Landscape Review Committee
Hybrid In-Person & ZOOM Online Meeting
Wednesday, March 6, 2024 - 12:00 PM

DATE: March 6, 2024
TO: Landscape Review Committee Members
FROM: Tom Schauer, Senior Planner
SUBJECT: Landscape Plan Review (L 55-23), originally continued from January 17, 2024

DECISION, CONDITIONS, FINDINGS OF FACT AND CONCLUSIONARY FINDINGS FOR THE APPROVAL OF A LANDSCAPE PLAN REVIEW FOR PROPERTY AT 2035 & 2045 SW HWY 99W.

DOCKET: L 55-23 (Landscape Plan Review)

Figure 4. Applicant's Proposed Landscape Plan and Planting Plan

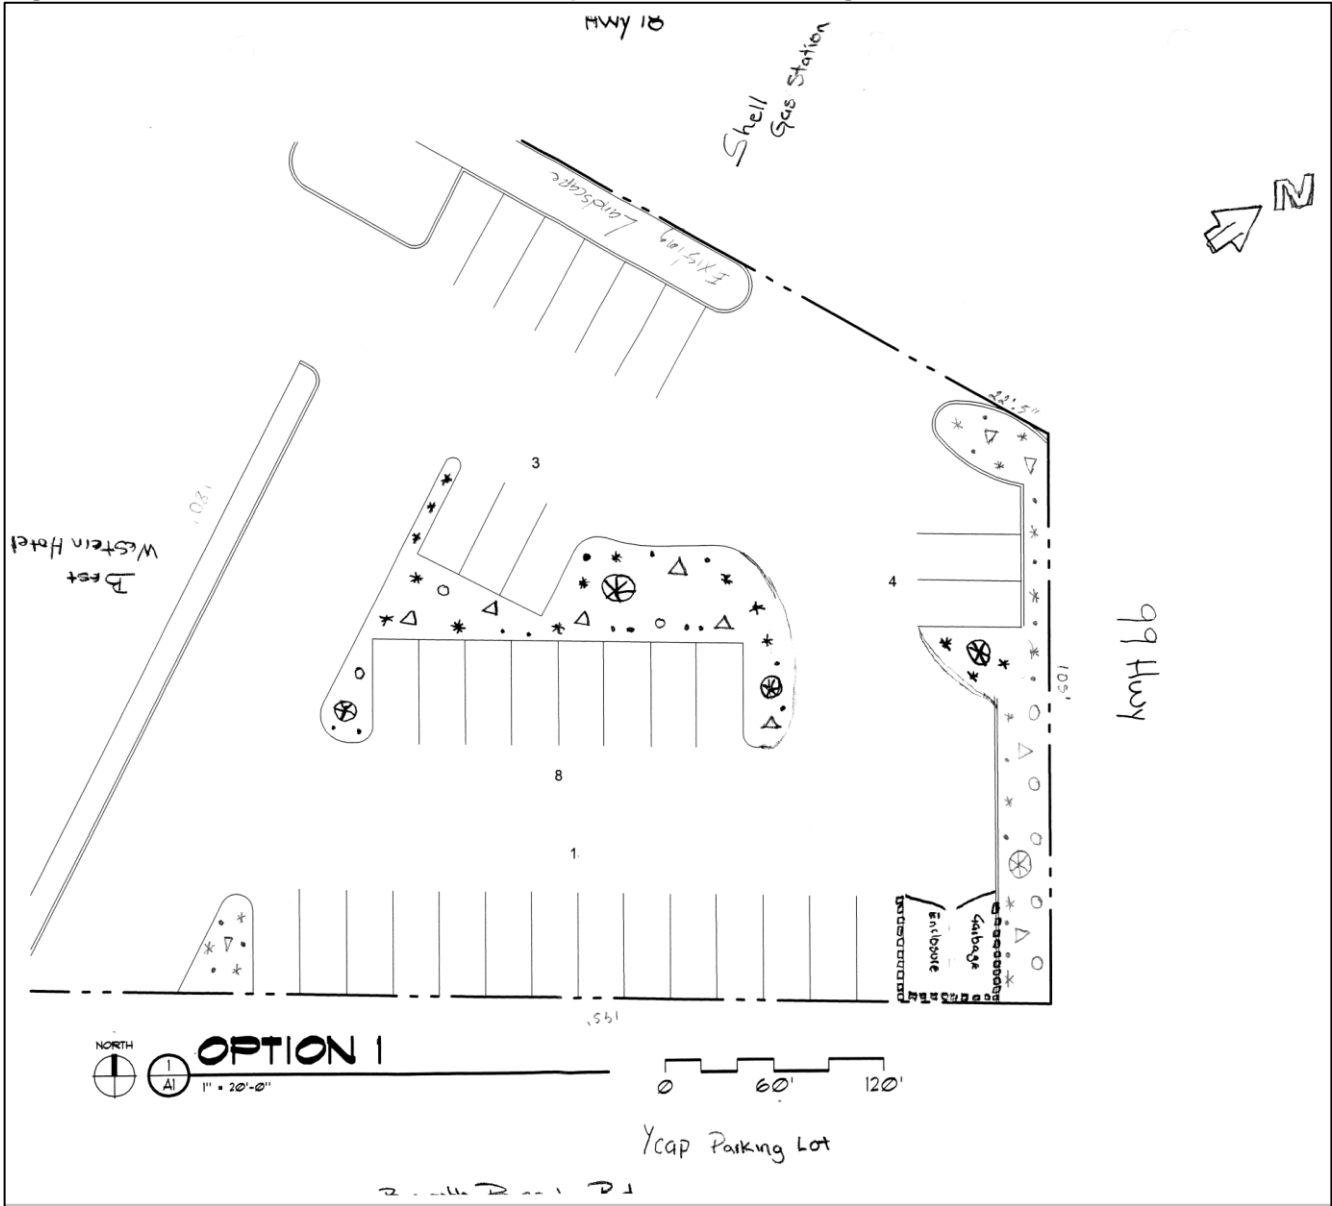
The applicant's originally proposed landscape plan and planting plan is shown in **Exhibit 4. Exhibit 5** shows an approximate overlay of the site plan/landscape plan over the aerial photo (before the restaurant building was demolished).

The applicant's original proposed plan shows a trash enclosure to remain near the southeast corner of the property. The existing enclosure is chain-link with slats. The proposed plan would also add landscaping between the parking spaces abutting Hwy 99W and sidewalk along Hwy 99W, where the spaces were abutting the sidewalk.

It appears the right-of-way/property line may be approximately 18" from back of sidewalk. The applicant shall verify the location of the property line relative to the sidewalk and identify any landscaping and/or improvements that would be within the public right-of-way.

1. The base map used for the landscape plan, and the landscape plan, need to accurately show the following information:
 - a. Relationship between the property lines and the distance from the back of sidewalk to the property line to show extent of landscaping within the public right-of-way. If any trees are within the public right-of-way they will need to be selected from the approved street tree list, minimum 2" caliper, and comply with street tree planting requirements.

- b. Location of sanitary sewer easement/sewer main on the property. Trees should not be planted over the easement.
 - c. Location of facilities described in the comments from McMinnville Water and Light, and demonstration that plant materials won't conflict and will meet required separation based on applicable standards.

2. A revised landscape plan and plant schedule, which needs to include the following:
 - a. The landscape plan needs to show the proposed trees and plant materials on the plan to reflect their mature size, shown to scale.

- b. Reflect the items in the conditions recommended by staff, including the end island recommended by staff at the east end of the row of parking along the northerly property line, a tree in the end island at the west end of the row of parking along the south property line, proposed method of screening of the southerly row of parking from the property to the south, incorporate the two cherry trees into the landscape area along Hwy 99W consistent with the September 24, 2010 approved revision to the original landscape plan L 92-4, show proposed curbing.

- c. Ensure the number of trees and plant materials indicated on the plan and in the planting schedule are consistent.
 - d. Provide scientific name and common name for proposed plant materials and varieties sufficient to describe the proposed plant materials. Some listed materials, including "Hako" did not provide sufficient identifying information.

Figure 6b. Applicant's Updated Landscape Plan, Plant List, Notes, and Details

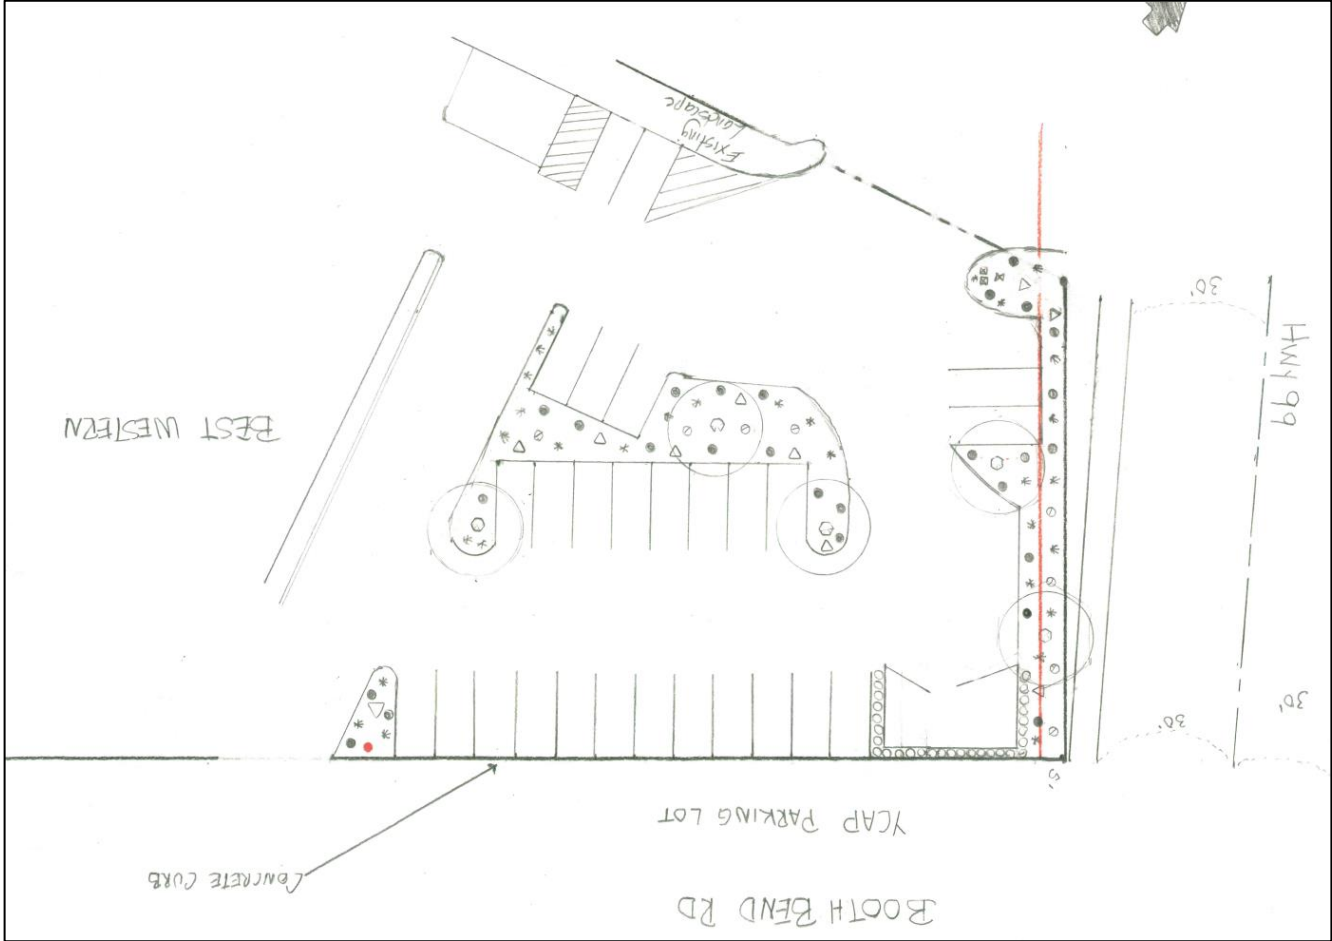
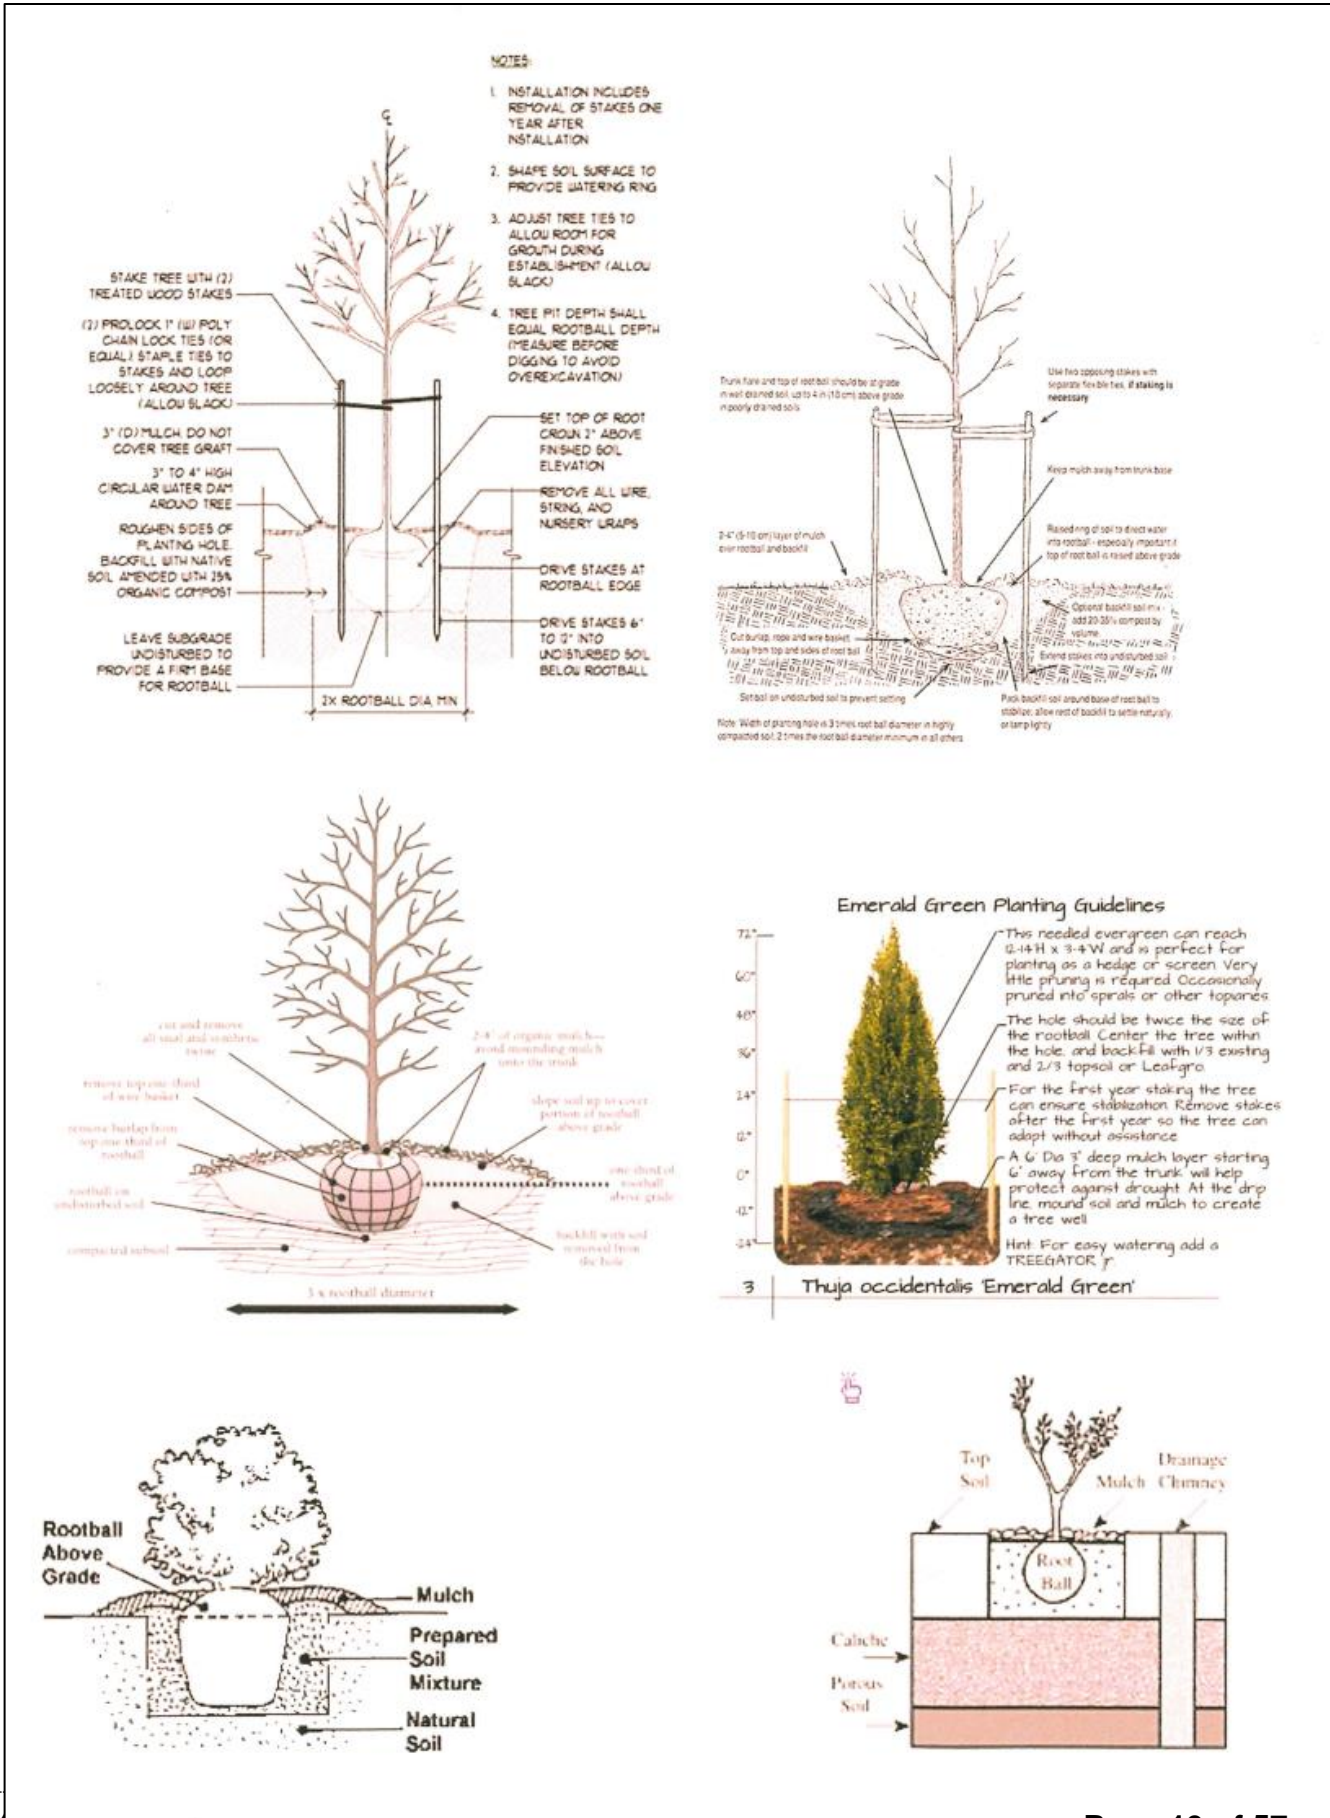
- a. ~~Verify the location of the property line relative to the back of sidewalk and show any landscaping or improvements that would be in the public right-of-way between the property line and back of sidewalk.~~ **Update the 2/23/2024 landscape plan to show the proposed plant materials and irrigation between the property line and back of sidewalk along Highway 99. Any irrigation within the right-of-way shall be consistent with ODOT standards and subject to ODOT approval. It is typically limited to drip irrigation lines.**

- b. ~~Add a landscape end island to the east side of the proposed new parking spaces along the north property line, to include a tree and landscaping.~~ ***Note: the proposed parking spaces along the north property line have been revised, with the number of parking spaces reduced so they don’t encroach into the drive aisle as they did on the original submittal.***

- d. Provide trees in the landscape area along Hwy 99W consistent with the original landscape plan approval L 4-92, including two cherry trees at the location shown in the map approved on September 24, 2010. **Update the 2/23/2024 landscape plan to add an additional cherry tree along the Highway 99 frontage between the two cherry trees shown there (one along the frontage and one in the parking end island further north).**

- j. To comply with 17.57.070(B)(1), (2), and (4) provide the following along the south property line abutting the parking spaces: sight-obscuring evergreen plantings, shade trees, fences, or combinations of plantings and screens. **The 2/23/2024 landscape plan shows a concrete curb along the south property line but doesn’t reflect screening.**

- k. To comply with Section 17.60.080(D) of the Zoning Ordinance, parking spaces along the south property line shall be contained by a curb or bumper rail to prevent a motor vehicle from extending over the adjacent property. **Concrete curbing is proposed on the 2/23/2024 landscape plan, which would meet this requirement.**

- l. Curbing shall be provided around the interior landscape island.
 - m. Identify any proposed exterior lighting and method of shielding/downcast lighting. **The 2/23/2024 submittal and landscape plan doesn’t discuss whether any additional exterior lighting is proposed.**

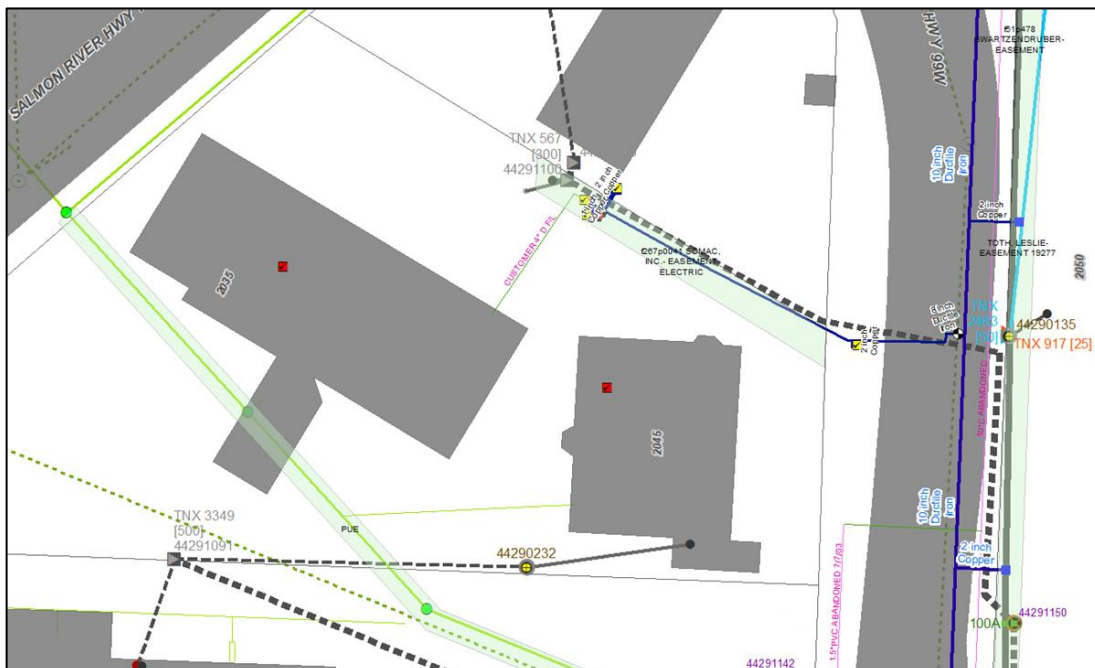
Water: Maintain clearances from new and existing public water facilities. See; FH-CLR, VAULTCLEAR, VR & WMCLEAR,

Power: MW&L has a utility pole that is in conflict with proposed landscape and parking lot area. Pole will need to either be relocated, protected, or removed. Please contact Kevin Skipper, Customer Engineering Supervisor at McMinnville Water and Light (503) 472-6919 x 6 or by email kas@mc-power.com, with any questions.

MW&L has underground power facilities located in the area. Prior to any digging or excavation, locates must be called in. Please contact Kevin Skipper, Customer Engineering Supervisor at McMinnville Water and Light (503) 472-6919 x 6 or by email kas@mc-power.com, with any questions.

In answer to your question concerning MW&L easements on R4429BD 02700, see the drawing below showing the easements in green. I've also attached a copy of the easement.
